## STAFF REPORT SUMMARY

To: Edgerton Planning Commission  
Fr: Kenneth Cook, AICP, CFM, Community Development Director  
Re: FP2017-01 for Final Plat for Inland Port XL, located West of Waverly Road and South of 181<sup>st</sup> Street.

To: Edgerton Planning Commission  
Fr: Kenneth Cook, AICP, CFM, Community Development Director  
Re: FP2017-01 Final Plat for Logistics Park Kansas City Rail Served-First Plat

To: Edgerton Planning Commission  
 Fr: Kenneth Cook, AICP, CFM, Community Development Director  
 Re: Application FS2017-01 for Final Site Plan for Inland Port XXI, located South of 191<sup>st</sup> Street and East of Four Corners Road.

## LOGISTICS PARK KANSAS CITY RAIL SERVED - FIRST PLAT

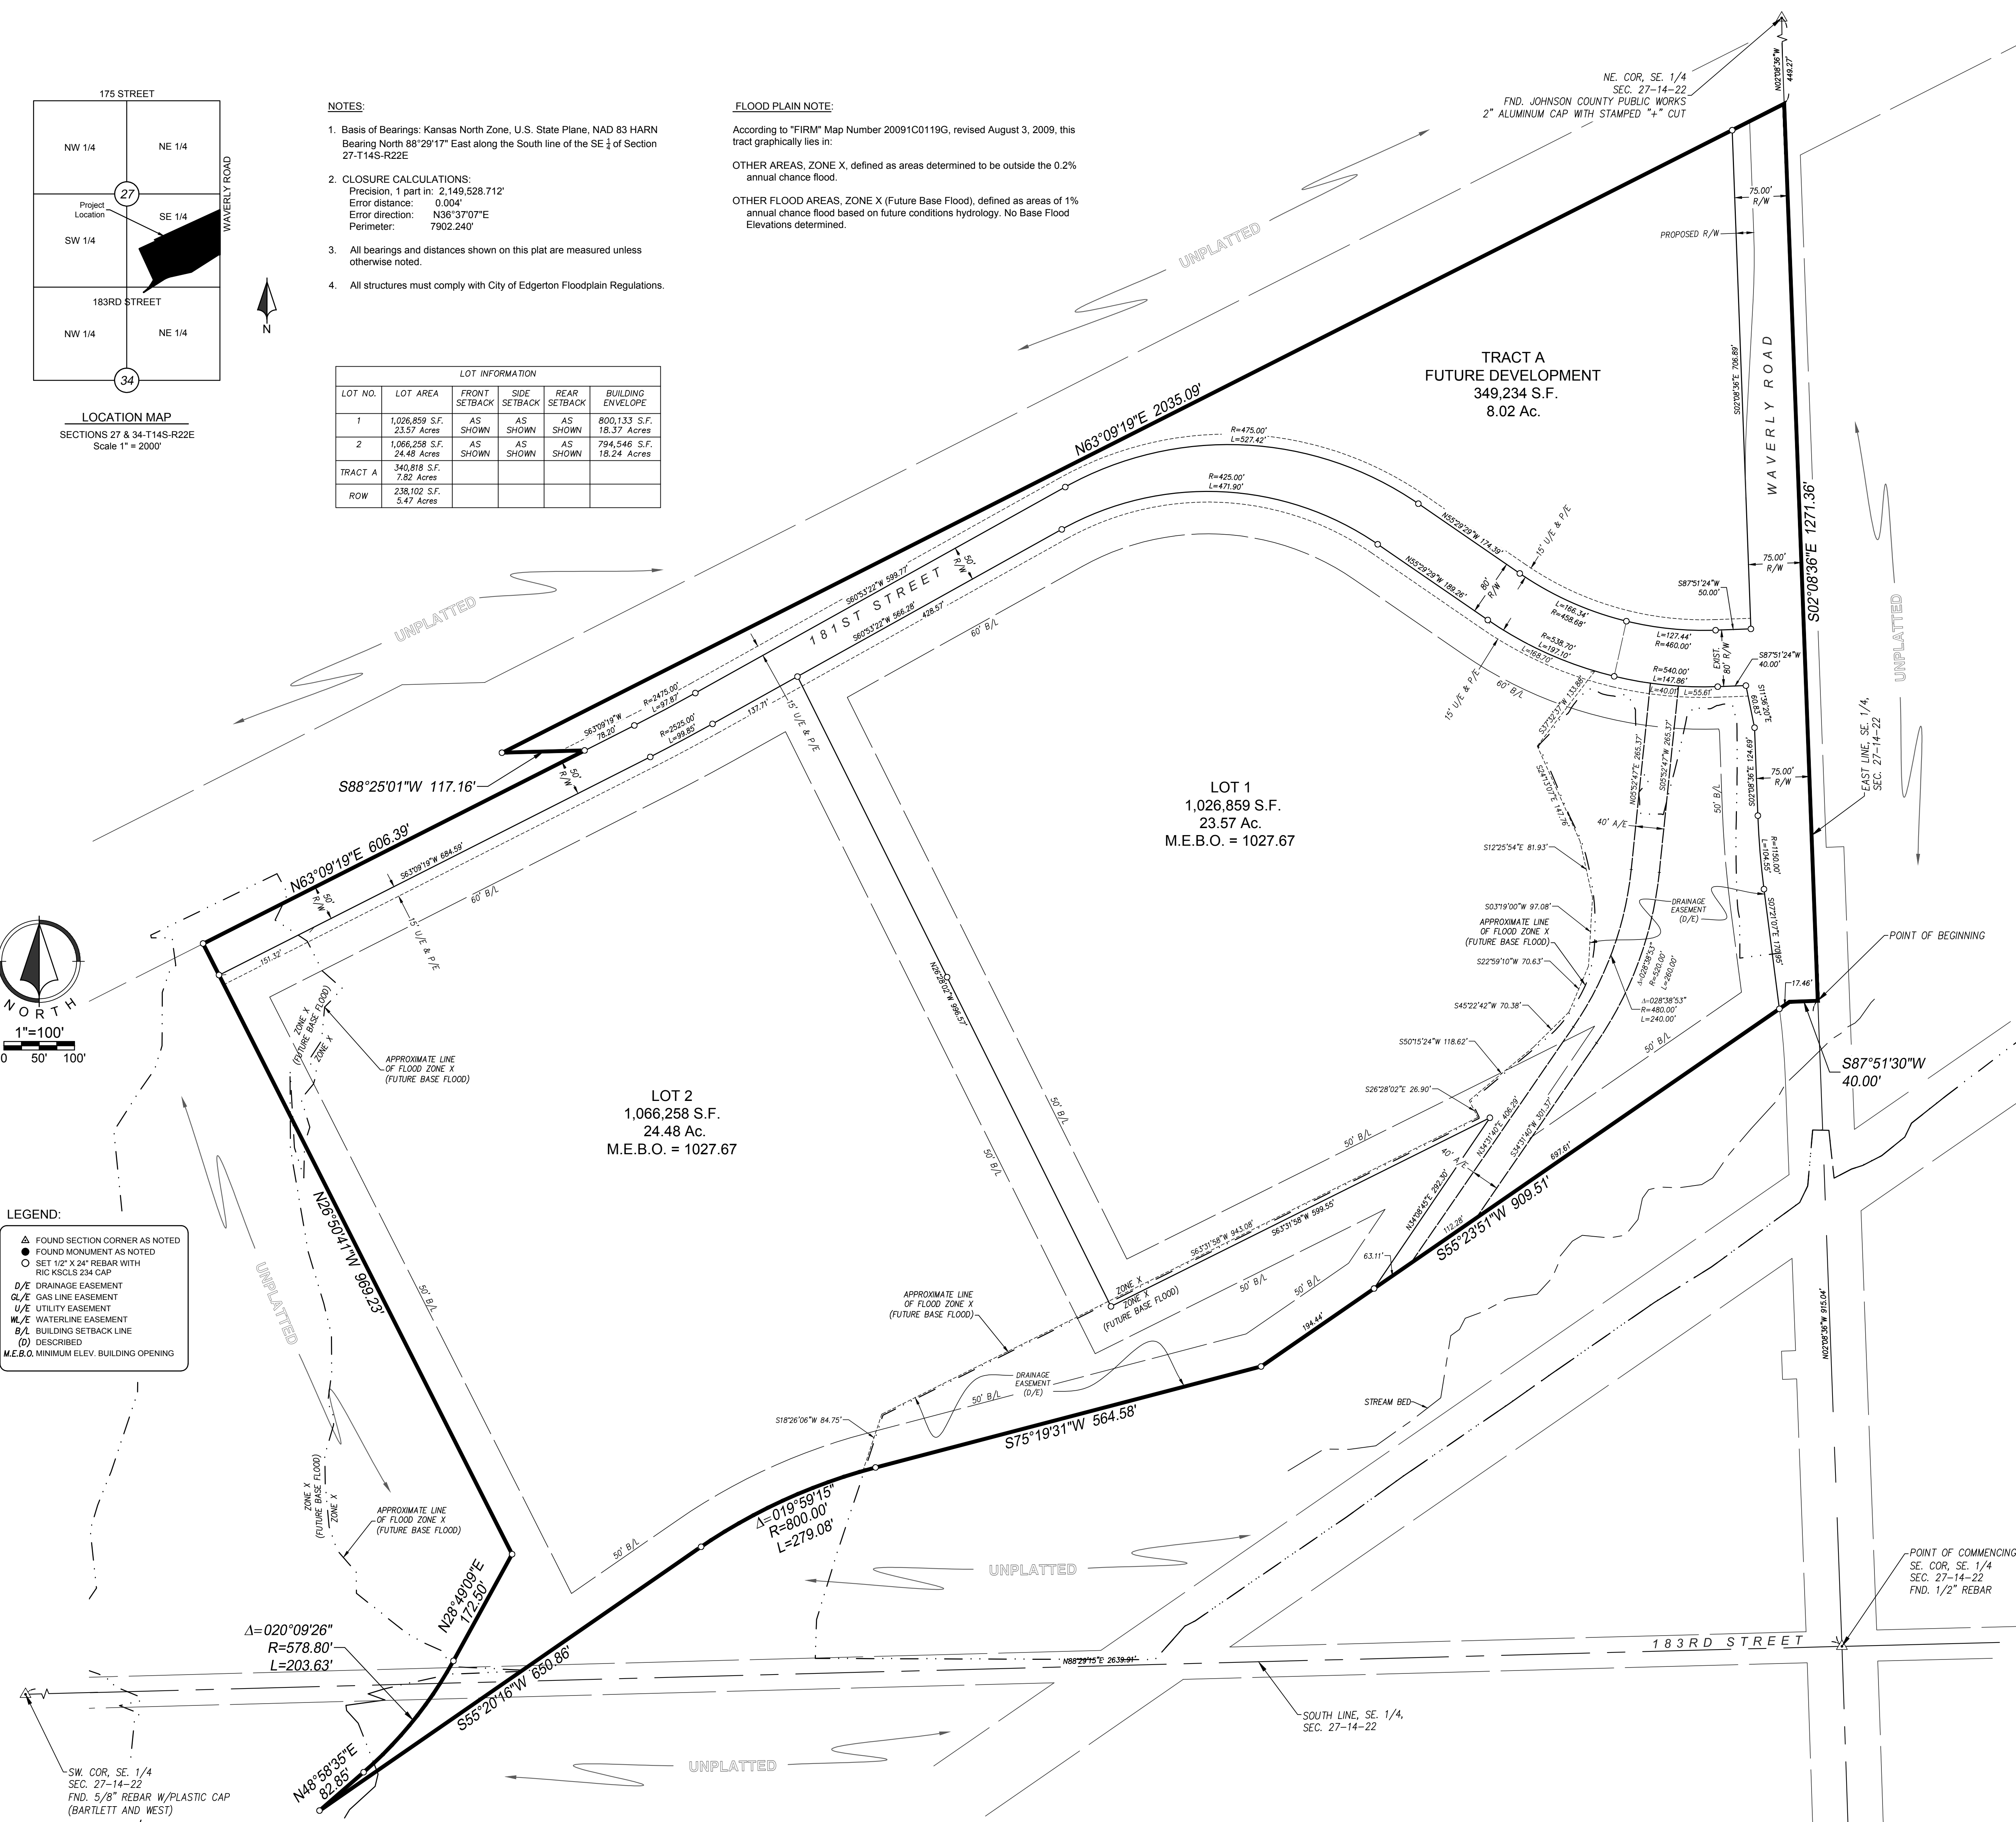
1. The Legal Description needs to be updated
2. Add dedication language for the drainage easement.
3. Add a notation to the plat in regards to the hard packed gravel road.

2. The words "FINAL PLAT" followed by the name of the subdivision at the top of the sheet, and then followed by a metes and bounds description of the tract. *Staff would suggest that the name would appear to be incorrect and might create problems in being recorded at the County. The Plat is titled, Logistics Park Kansas City Rail Served – First Plat. Final Plat Complies*

- *The legal description does not match the graphic portion of the plat.*
  - *The three found sectional corners should show what is on the cap and the origin of the corner and any other found monuments should show the origin, if known. Specifically, SE Corner 27-14-22, at point of commencement.*

5. Individual notations and a TABLE showing: lot area, setbacks, and building envelopes. *Table is incomplete please add appropriate information. Update Final Plat.*

6. A number for each lot, starting (if practical) in the northwest corner. **Final Plat Complies.**
7. All easements with widths, and roads with curve data. *Please add dedication language for the drainage easement. Update Final Plat.*

11. An instrument of dedication for all roads and easements. *Additional wording needs to be added to the plat that stating Tract A will be utilized as open space and when the Tract is to be developed, it will be replatted to become eligible for building permit. Update Final Plat.*

## LOGISTICS PARK KANSAS CITY PHASE III, FIRST PLAT

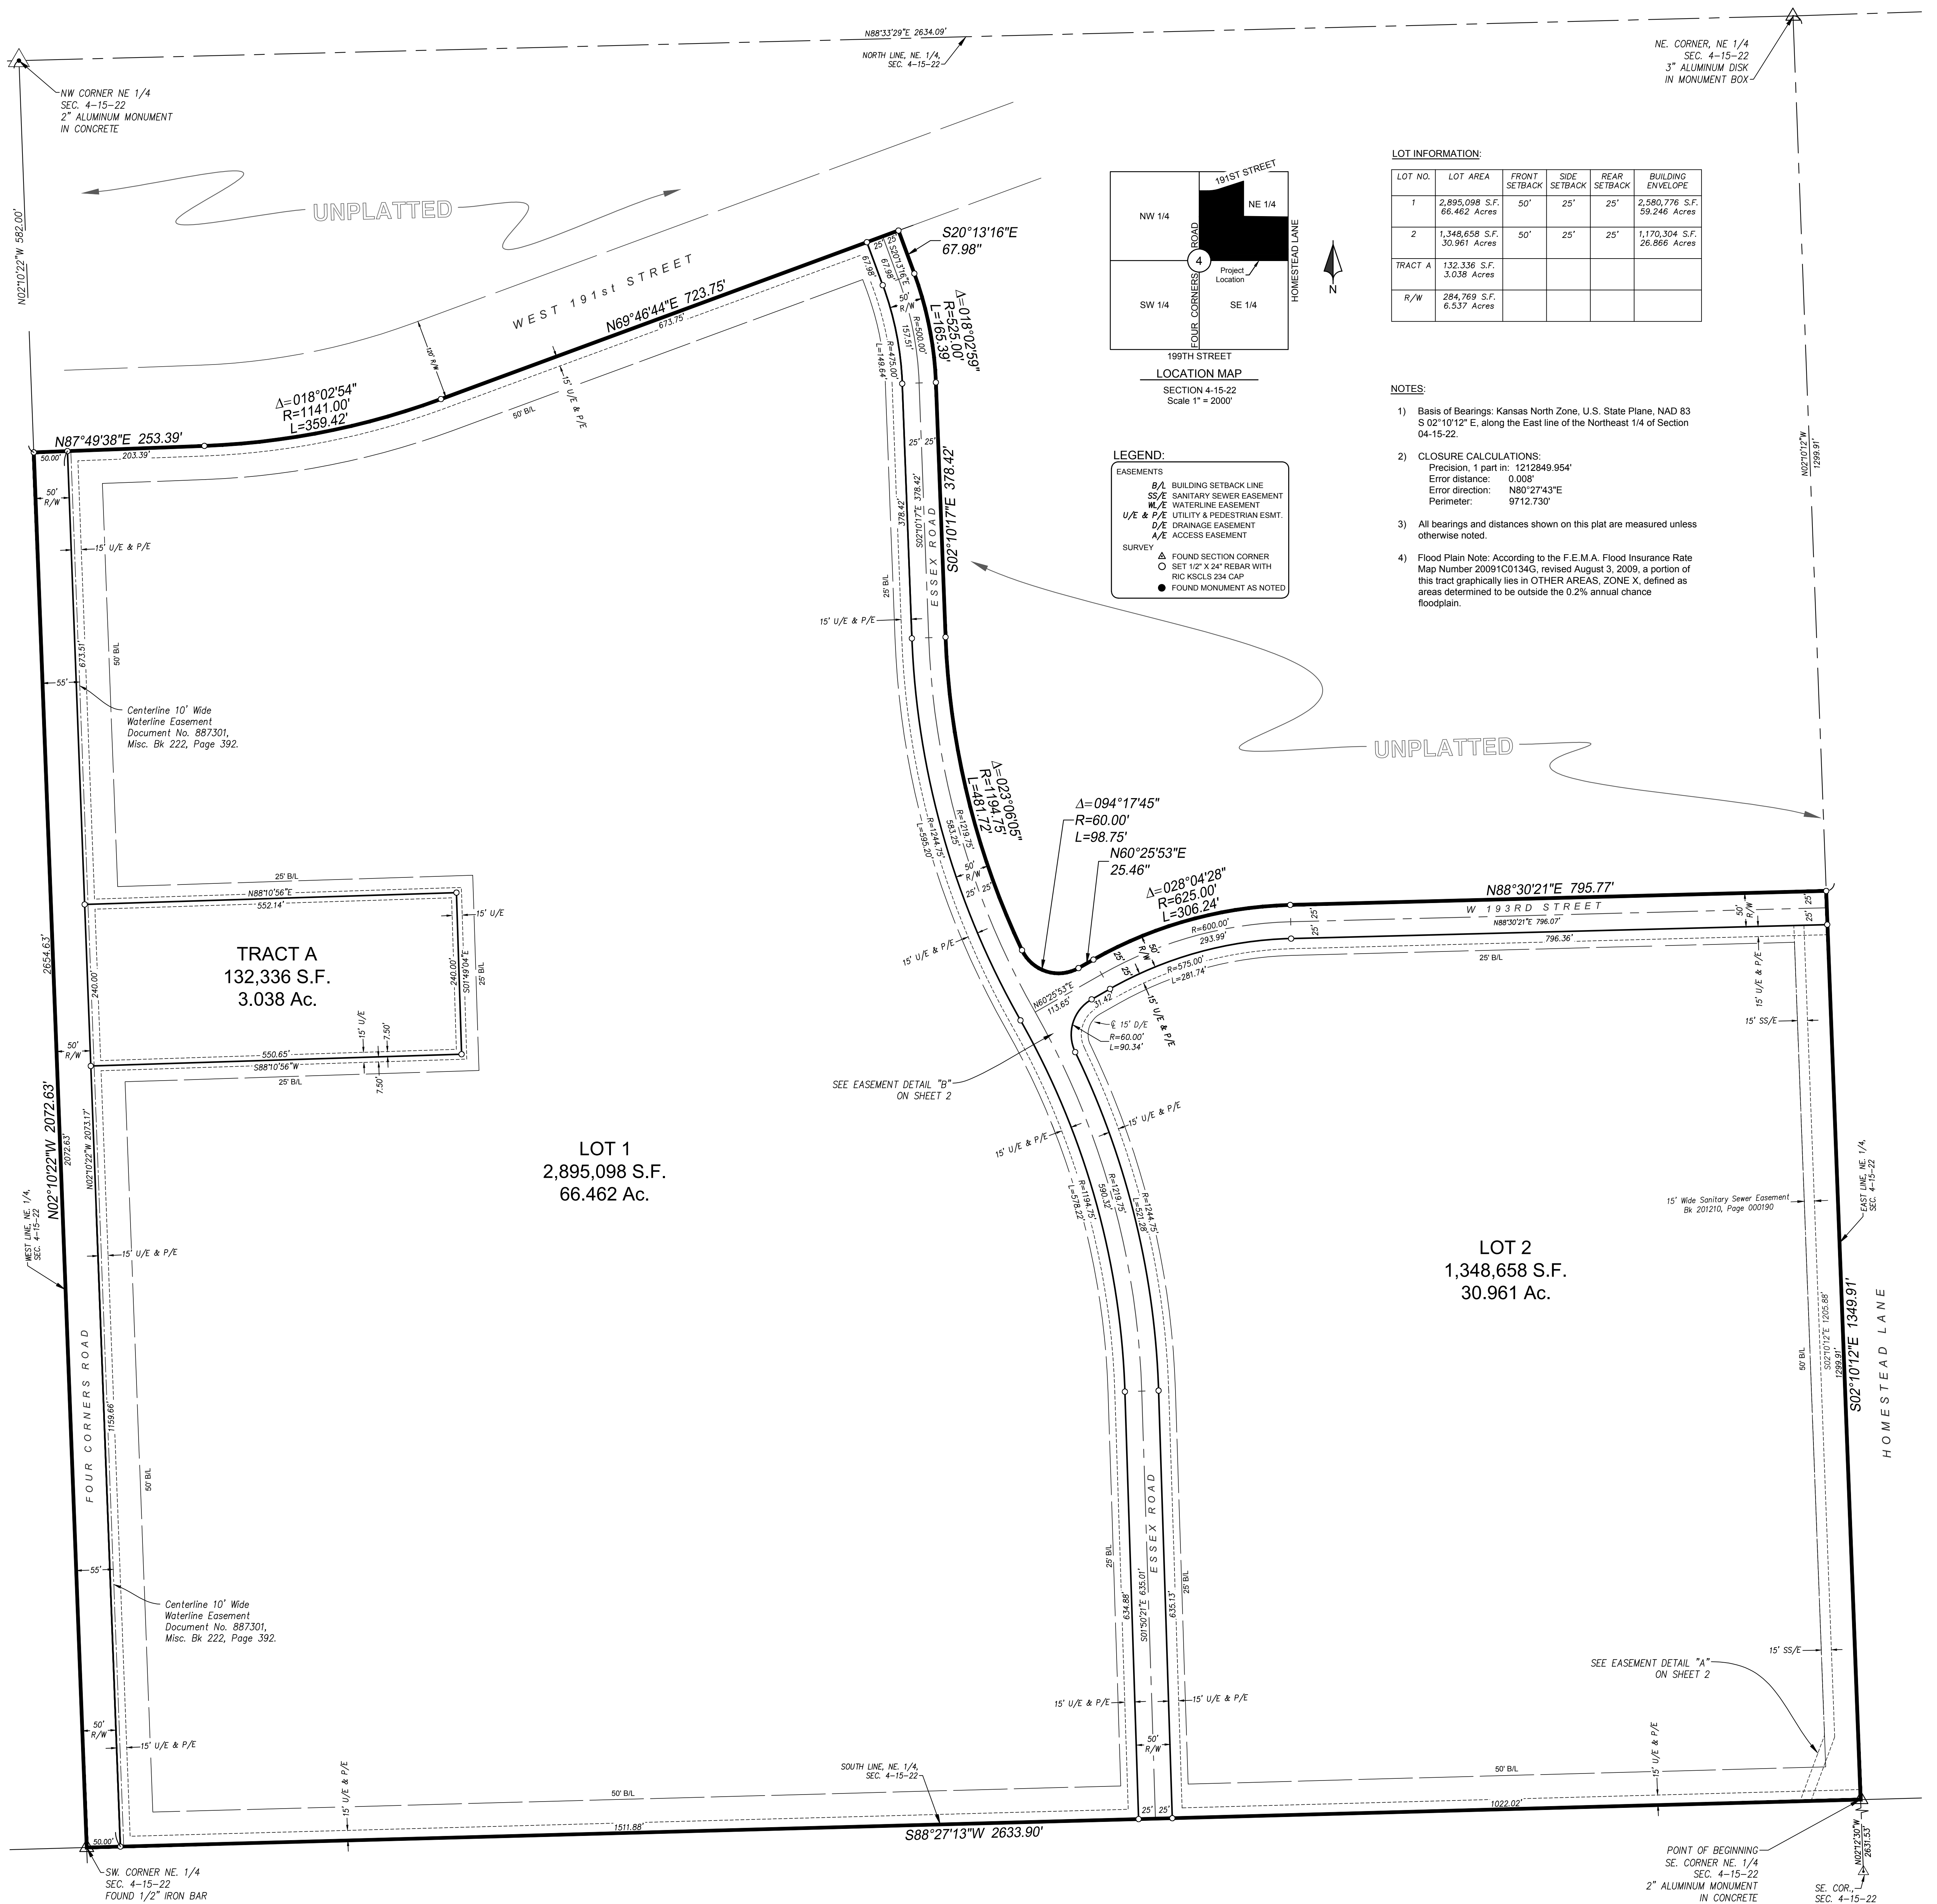
1. The Plat needs to be updated to better show the roads that have already been dedicated to the City.
2. Information in regards to the dedication of ROW needs to be included on the plat.

- *Remove the Utility and Pedestrian Easement along the 191<sup>st</sup> Street ROW.*
  - *Remove the Pedestrian Easement along the Southern boundary of the property.*

- *A note on the plat drawing specifies "See Easement Detail 'B' on Sheet 2". There is no such detail on sheet 2.*
  - *An easement should possibly be included for the location of the proposed pump station if we feel comfortable with the location and size of the proposed facility.*

- *Temporary easements should be granted at the South end of Essex to provide for trucks to be able to turn around. This can be done on a separate document and would not need to be shown on the plat.*

- *It is currently anticipated that Four Corners Road will be vacated and staff would suggest that this should be shown on the plat. A portion of the ROW for Four Corners Road will need to remain to provide access to the dwelling located on the West side of the ROW. Staff also suggests that wording should be added to the dedications which would describe the portions of Four Corners Road to be vacated. It is anticipated that agreements will be made in regards to the vacation of this ROW before the Plat is taken to City Council.*

14. Private travel easements. *A private travel easement may need to be shown along those portions of Four Corners Road that would be vacated in order to provide access to the property located to the South of Lot 1. Update Final Plat.*
